Date: 20 May 2021
Your Ref: NYM/2020/1018/FL
Our Ref: 006/2020/02

PROPOSED REVISIONS: Full/detailed planning for a 150 space visitor car park, vehicular bridge, and other ancillary infrastructure (pay stations, electric vehicle charging points, CCTV poles and cycle stands/storage) and a small section of pedestrian route/footpath on 0.59 hectares (1.47 acres) of land on the former timber yard, East Row, Sandsend (Planning Application Ref: NYM/2020/1018/FL)

Report title:	Designers Response to Stage 1 RSA
Date:	May 2021
Document reference and revision:	11613-004-01
Prepared by:	Sanderson Associates (Consulting Engineers) Ltd
On behalf of:	The Mulgrave Estate

Drawing Number	11613-004	Rev	
----------------	-----------	-----	--

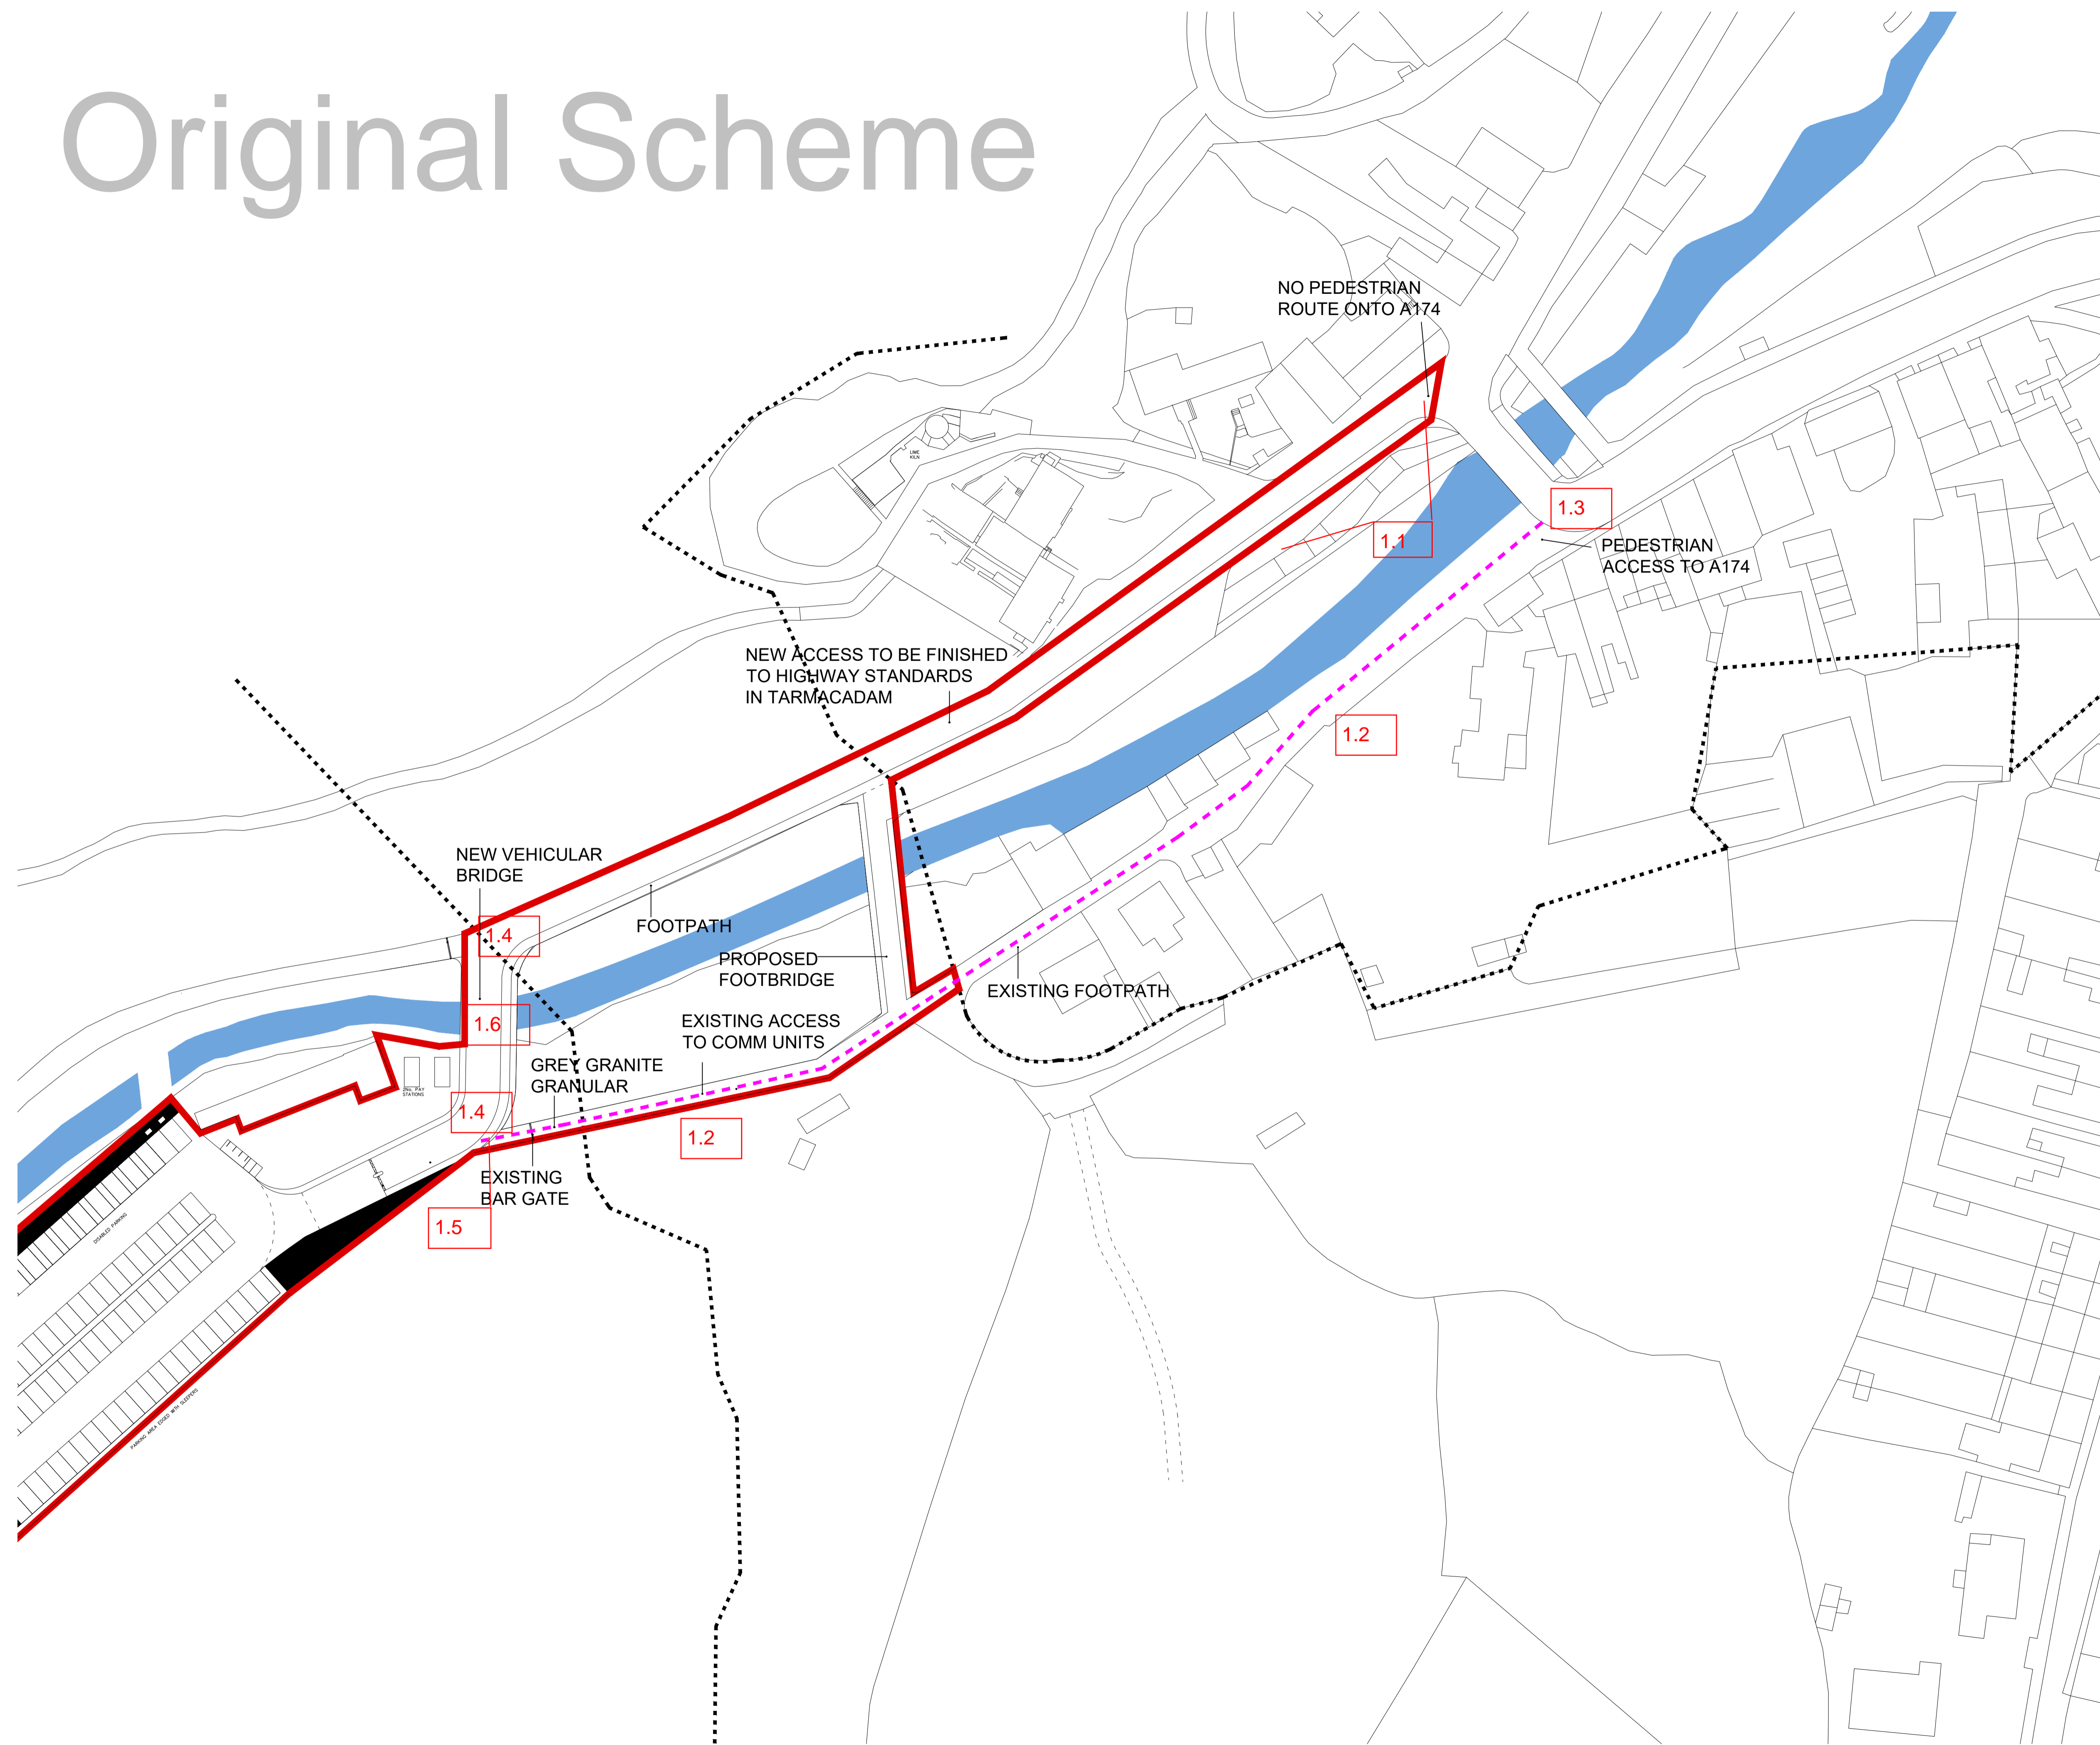
Summary: Drawings 11613-003 & 004 do not show if the existing parking (adjacent to the A174) is retained and whether pedestrian facilities will be provided along the new access road to access the existing shops, Fish Cottage, other buildings and the woodland. If the car parking is retained in an 'ad hoc' fashion adjacent to the new access road this could lead vehicles manoeuvring on and off the access road in conjunction with people on foot accessing the shops and woodland along the access road leading to pedestrian / vehicle conflict and vehicle / vehicle manoeuvring collisions.

Summary: Drawing 11613-004 indicates that there is no pedestrian route on to the A174 via the new vehicle access road and that the pedestrian access to / from the car park to the A174 is along the existing footpath / private drive to minimise foot traffic across East Row Bridge. The existing footpath / private drive is in very poor condition in terms of its surfacing and drainage for access on foot and there is no indication of whether improvements are proposed. It is also used for vehicular access to the properties along the private drive. The existing footpath route in its present condition would not be attractive for use by people with pushchairs / wheelchairs, young children and those with mobility / visual impairments and vehicle occupants would likely be attracted to use the new access road since there is a footpath along part of it (between the two proposed bridges) and it is then only a short distance (circa 110m) to the A174 where there are the existing shops and

Summary: Drawings 11613-003 & 004 do not show if any pedestrian improvements are proposed at the junction of the existing footpath / private drive with the A174. There are existing part time (21 March to 30 September) waiting restrictions on the adopted part of the A174 junction area and a car was observed parking on the private drive part against the existing footway, effectively blocking access to the footway from the private drive. Furthermore, there are no existing dropped kerbs (or tactile paving) or a clear route to indicate how pedestrians should join the existing footway from the end of the private drive. Inadequate pedestrian facilities could lead to conflict between pedestrians and vehicles in the private drive junction area and where vehicles are also negotiating the sharp bend on to the East Row Bridge.

Summary: Drawing 11613-004 does not show the vehicle route arrangements at the ends of the proposed car park vehicular bridge, carriageway widths or vehicle swept paths. If the carriageway width is inadequate to allow two way flow at the bridge ends in conjunction with restricted forward visibility across the bends it could lead to head on vehicle collisions.

Summary: Drawing 11613-004 does not clearly show the proposed pedestrian facilities and dimensions where the pedestrian access route joins the access road just to the south of the vehicle access bridge or across the bridge. In addition 2 pay stations are shown on the northern side of the access road which would require pedestrians to cross the access road from the pedestrian access route. Inadequate pedestrian facilities and width could lead to conflict between pedestrians and vehicles where pedestrians need to cross the access road or walk along it to access the car parking area.

Summary: Drawing 11613-004 does not show the proposed dimensions of the vehicle access bridge. It is not clear from the drawings if the car park would remain open if maintenance operations are needed to the bridge. Adequate width would be required to allow for at least single file traffic (vehicle and pedestrian) together with working room for maintenance operations if the car park is not closed. Inadequate width could lead to conflict between pedestrians / vehicles and construction operatives carrying out maintenance activities on the bridge.
